SERVICE BULLETIN

SB1245

ADDRESSEES	: Owners and operators of coaches listed under 'Application'
VEHICLE MODEL	: TD925
SYSTEM/SUBSYSTEM	: Body and accessories – driver's seat
BULLETIN TYPE	: Safety Recall Program – NHTSA campaign ID number 12V-323
DATE	: October 25 th , 2012
SUBJECT	: Driver's seat anchorage assembly – Replacement of riser and floor adapter plate
TERMS & CONDITIONS	: Refer to the warranty section further in this Bulletin.

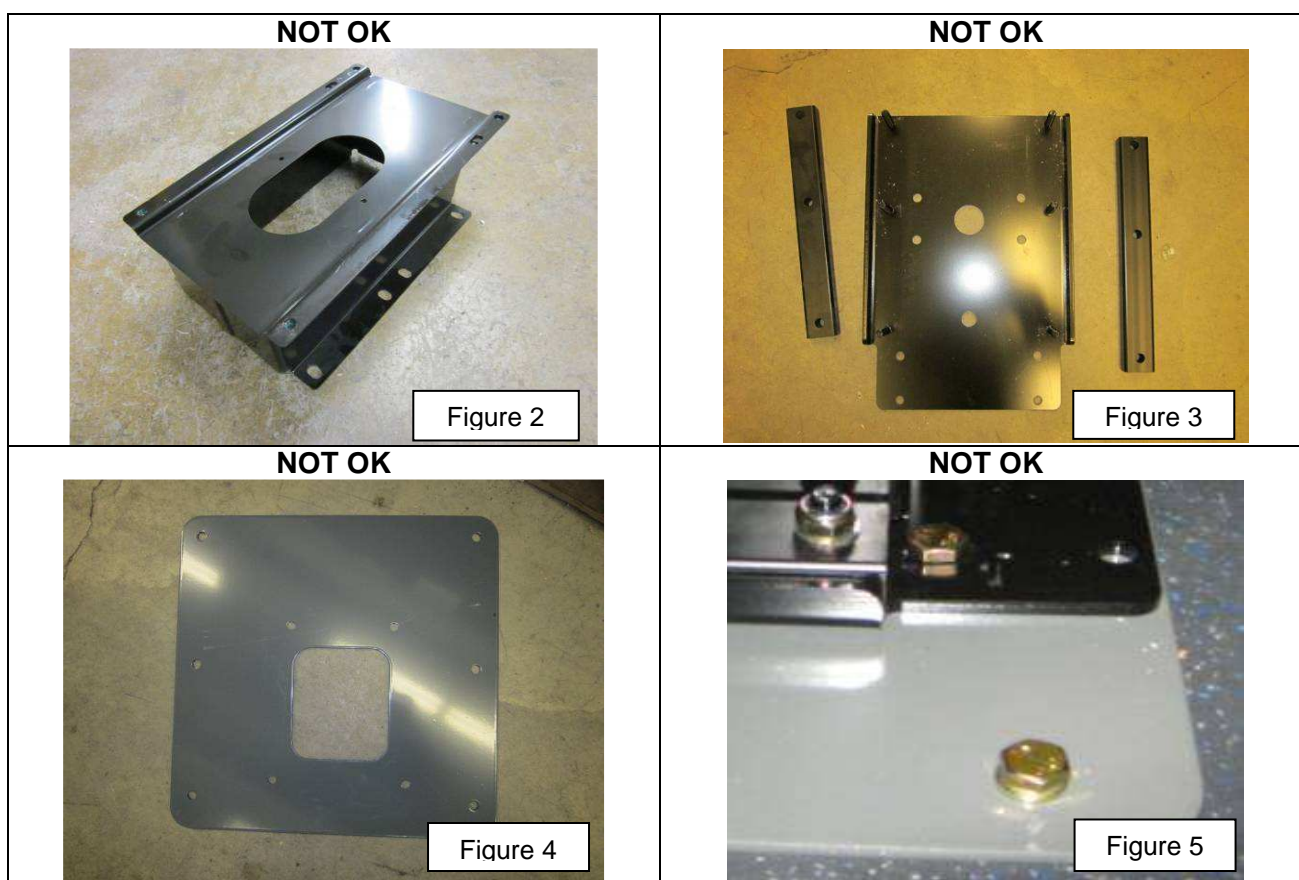
Noncompliant parts: ISRI riser, ISRI adapter plate, Van Hool floor adapter plate and fixation material (Figure 2, 3, 4 and 5)

VH reference	Description of noncompliant parts	Qty.	Refer to
11307654	ISRI riser	1	Figure 2
10672095	ISRI adapter plate	1	Figure 3
11134267	Van Hool floor adapter plate	1	Figure 4
660224503	Screw, M10 x 1.50 x 30, grade 8.8, DIN933	6	Figure 5

**Compliant parts: ISRI riser, Van Hool floor adapter plate and fixation material
(Figures 6 and 7)**

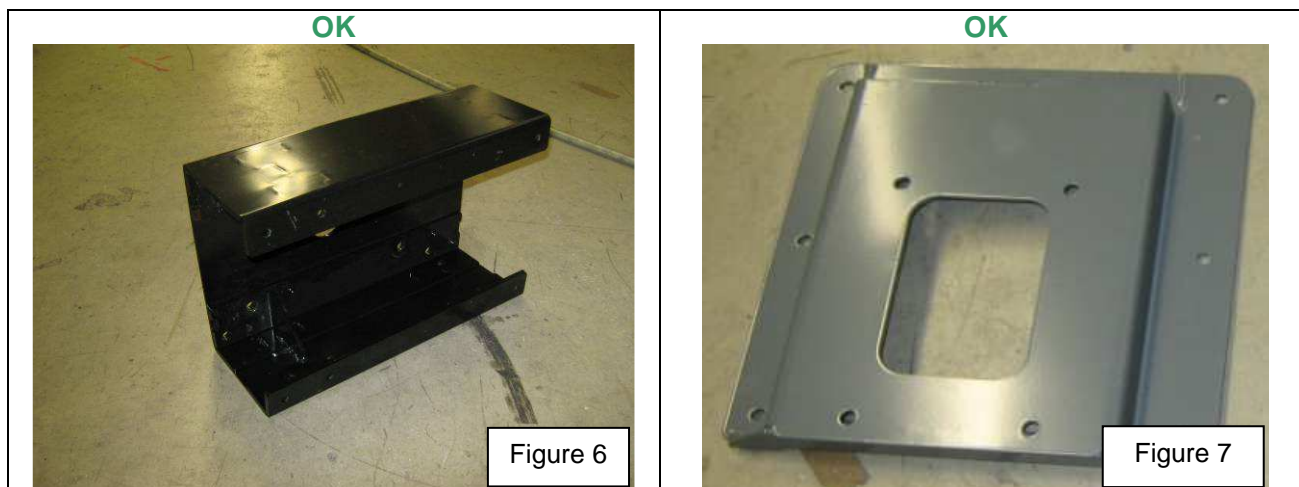
VH reference	Description of compliant parts (kit VH 11334125)	Qty.	Refer to
11319711	ISRI riser	1	Figure 6
11322918	Van Hool floor adapter plate (color: grey)	1	Figure 7
660222404	Screw, M8 x 1.25 x 25, grade 10.9, DIN 933	6	
660207116	Nut, self-locking, M8, DIN 985	6	
660226606	Screw, M12 x 1.75 x 35, grade 10.9, DIN 933	4	
660629103	Washer, flat, M12, 13 x 24 x 2.5 mm, DIN125	4	
660207406	Nut, self-locking, M12, DIN 980	4	
10527474	Screw, M10 x 1.50 x 35, grade 10.9, DIN933	6

Figure 24

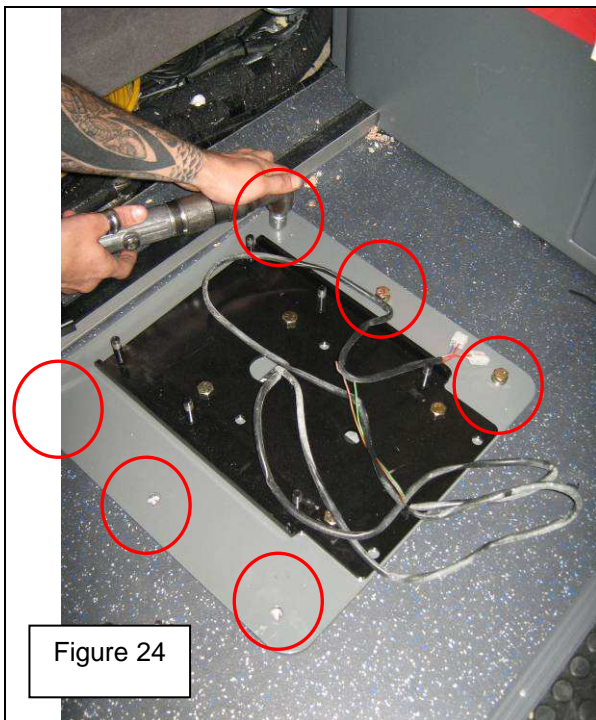
Unscrew the six M10 screws (two sides) (VH660224503). Keep all the washers and lockwashers apart for later re-use.

Figure 25

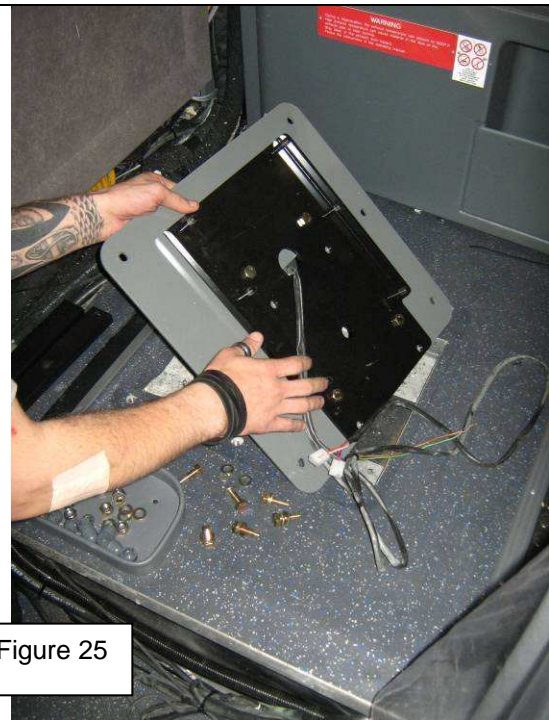
Lift the adapter plates (be careful with electric wires and pneumatic tubes).

Figure 32

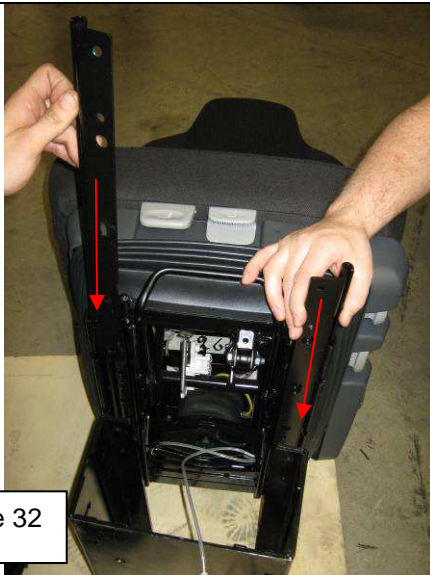
Do not remove the metal plates which were installed under the sliders (two sides).

Figure 33

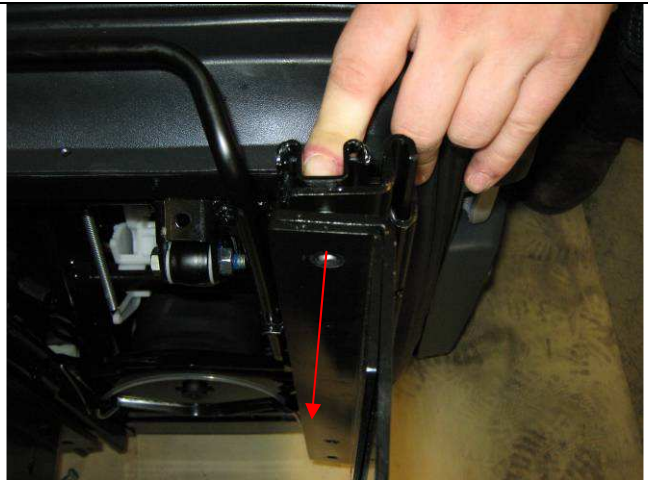
Secure the sliders and metal plates to the compliant riser (VH 11319711). Use two M8x25 grade 10.9 screws (VH 660222404) and two M8 nuts (VH 660207116) (two sides).

Figure 34

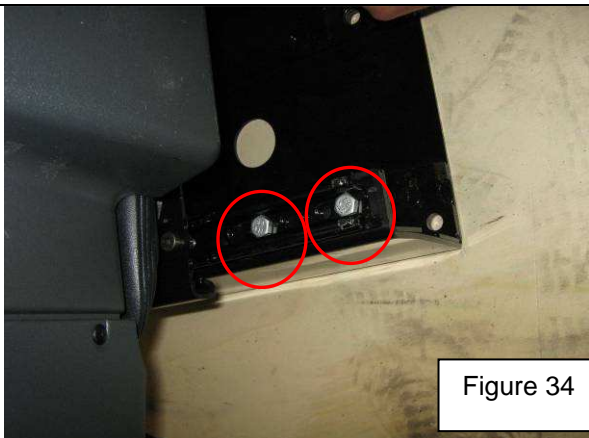
Move the driver's seat to the most forward position and secure the sliders and metal plates to the compliant riser. Use four M8x25 grade 10.9 screws (VH 660222404) and four M8 nuts (VH 660207116) (two sides).

Figure 39

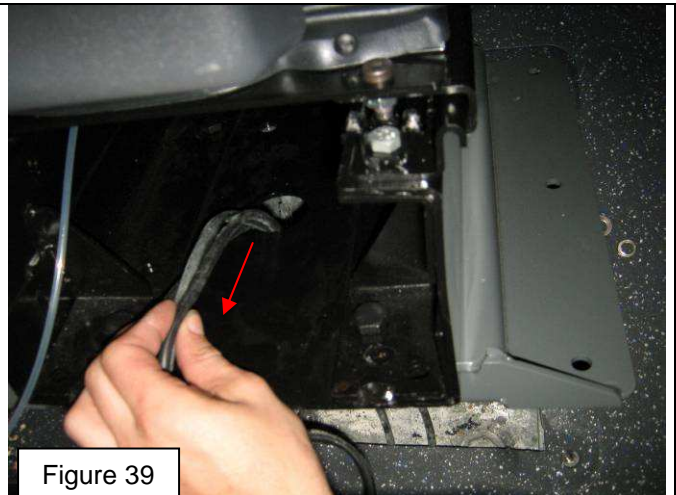
Pull the electrical wires through the holes of the riser and floor adapter plate.
